In the Drawings

REMARKS

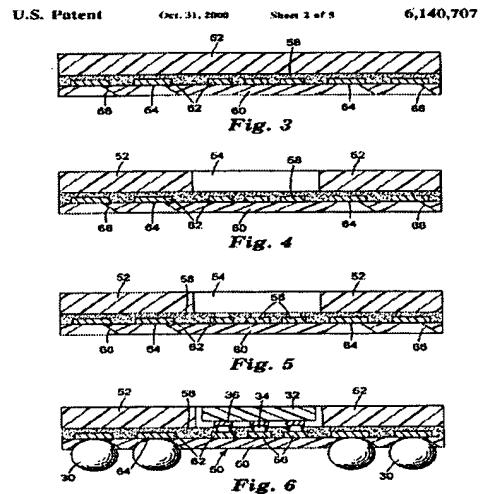
The most significant part of Plepys is actually the removal of the stiffener/heat sink from the area adjacent to the hot silicon chip (see drawing to the right). Plepys claims that this is advantageous because (a) the resultant shrinkage of the higher-CTE polymer adhesive (58) and tape (60) materials after the removal of the stiffener/heat sink (52) makes that exposed area very planar, which enhances the soldering of the chip, and (b) mounting the exposed chip (32) on the same side as the stiffener/heat sink (52) allows an additional heat sink to be applied directly to the chip from above. Note that without this additional heat sink (not shown) the cooling capabilities of the Plepys construction would be poor: the heat from the chip would have to travel into the copper (56) on the tape below, and then spread in the X-Y plane of the circuit (60) and up through the adhesive (58) to reach the stiffener/heat sink.
